City of Mississauga Memorandium: City Department and Agency Comments

File(s): A66.21 Ward: 11

The applicant requests the Committee to approve a minor variance to allow a height of an accessory structure (shed/play structure) of 4.00m (approx. 13.12ft) whereas By-law 0225-2007, as amended, permits a maximum height of an accessory structure of 3.00m (approx. 9.84ft) in this instance.

Property Address: 87 Vista Drive

Appendix 1 – Transportation and Works Comments

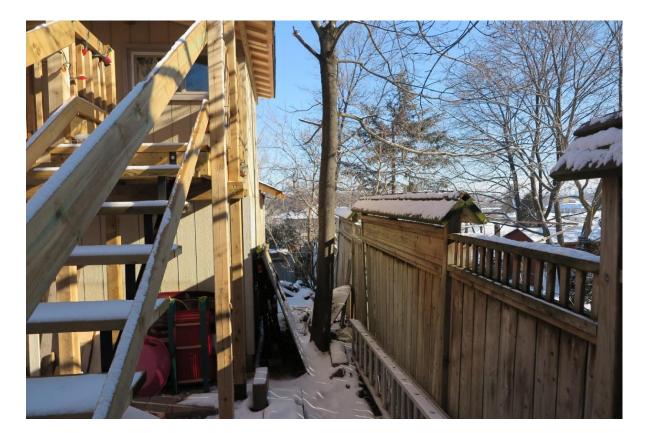
Enclosed for Committees easy reference are photos depicting the existing accessory structure (shed/play structure). We also note that we have no drainage related concerns with the structure.
